Access Compliance Report Public Rights-of-Way (Curb Ramps)

Main Street: NEWLAND_ST Cross Street: MADISON_AVE Location: NE

ADA ID: RPRK220203130432 Ramp Type: Type 4 - Parallel Initial Pass/Fail: Fail Overall Compliance: No Severity Score: 15

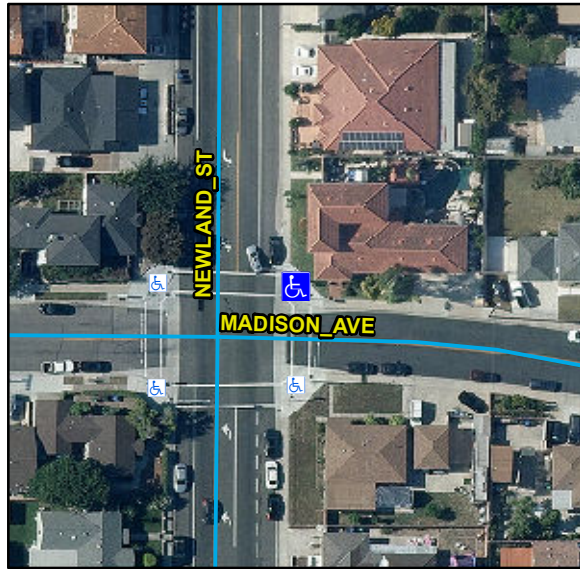
Compliance	Description	Data	Compliance	Description	Data
N/A	Ramp Length LT (in)	79	N/A	Ramp Length RT (in)	78
Yes	Ramp Width LT (in)	117	Yes	Ramp Width RT (in)	117
Yes	Ramp Run Slope LT (%)	4.7	Yes	Ramp Run Slope RT (%)	6.4
No	Ramp Cross Slope LT (%)	5.5	No	Ramp Cross Slope RT (%)	6.1
N/A	Landing Present	N/A	N/A	DWS Provided	N/A
N/A	Landing Length (in)	N/A	N/A	DWS Contrast	N/A
N/A	Landing Width (in)	N/A	N/A	DWS Length (in)	N/A
N/A	Landing Run Slope (%)	N/A	N/A	DWS Full Width	N/A
N/A	Landing Cross Slope (%)	N/A		DWS Offset Type	N/A
N/A	Landing Movement Obstructed?	N/A	N/A	DWS Offset Left (in)	N/A
	Landing Movement Type	N/A	N/A	DWS Offset Right (in)	N/A
N/A	Landing Shared	N/A			
N/A	Clear Space	Yes			
N/A	Clear Space To Crosswalk (in)	48			
N/A	Marked Crosswalk 1	Yes	N/A	Marked Crosswalk 2	Yes
	Crossing 1 Direction	W		Crossing 2 Direction	S
	Marked Crosswalk 1 Width (in)	144		Marked Crosswalk 2 Width (in)	144

Remove & Replace Curb Ramp With Two New Directional Ramps or Equivalent.

R304.5.3, STD 1115
